September 19, 2012

RE: Grand Junction Development Discussions and Related (Alewife, Charles River, Urban Ring rail)

Grand Junction Path Report - Analysis

Option 2: Trail with Bus Rapid Transit
Section 1: Charles River to Ft. Washington Park

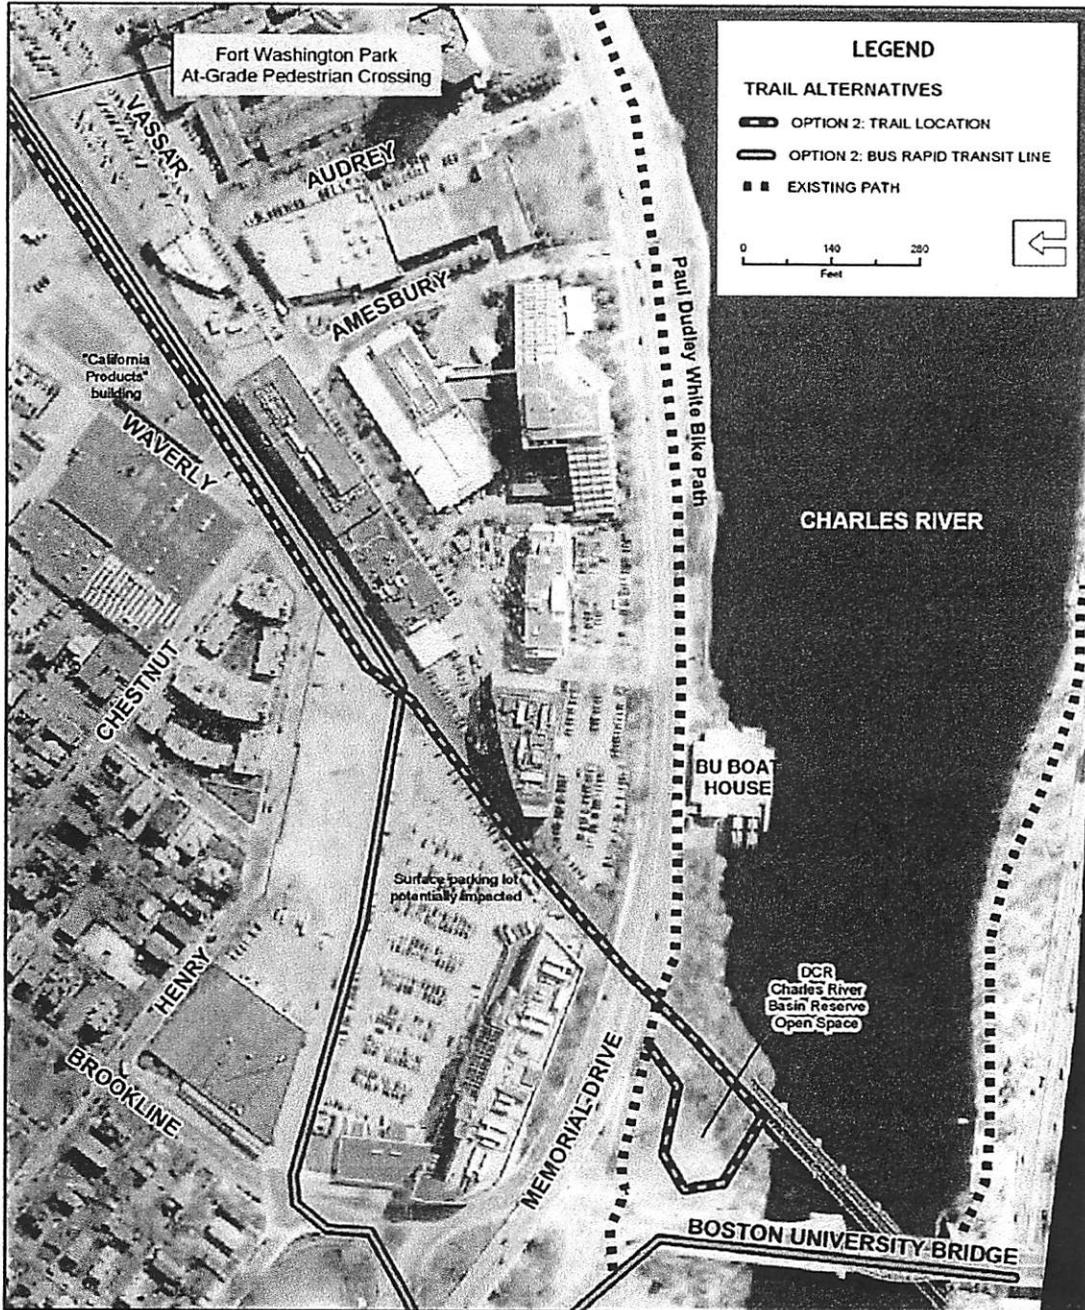
On page 3-5, after reviewing the planned destruction, back up the Grand Junction to the point where this broken light / dark line intersects with a light solid line. This is the point where responsible planning would connect the proposed small vehicle highway to Vassar Street by running the new highway between the two buildings through the opening to the right and then to Memorial Drive. Compare the amount of work and expense involved in the two routes and compare the convenience to bicyclists on the two routes. There is no meaningful competition between the two routes. The Vassar Street route is the better of the two on all counts.

Figure 4-2. Fencing Location

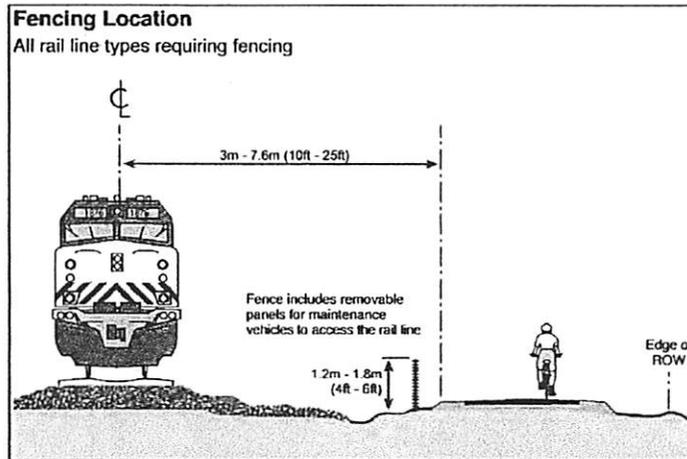
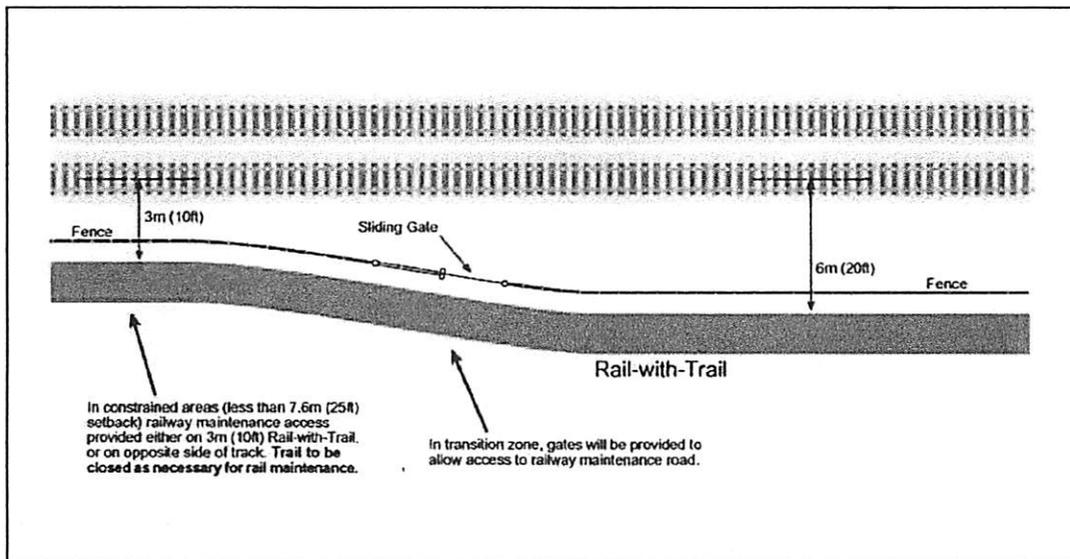
“Recommendation: Fencing should be installed along the corridor.”

No mention of animal impacts. After all, these people just killed hundreds of free animals as part of the totally wasteful destruction at Alewife.

Page 4-6 Refers to use of vegetation as barrier. Vegetation barrier is the latest of the many outrages at the Destroyed Nesting Area.
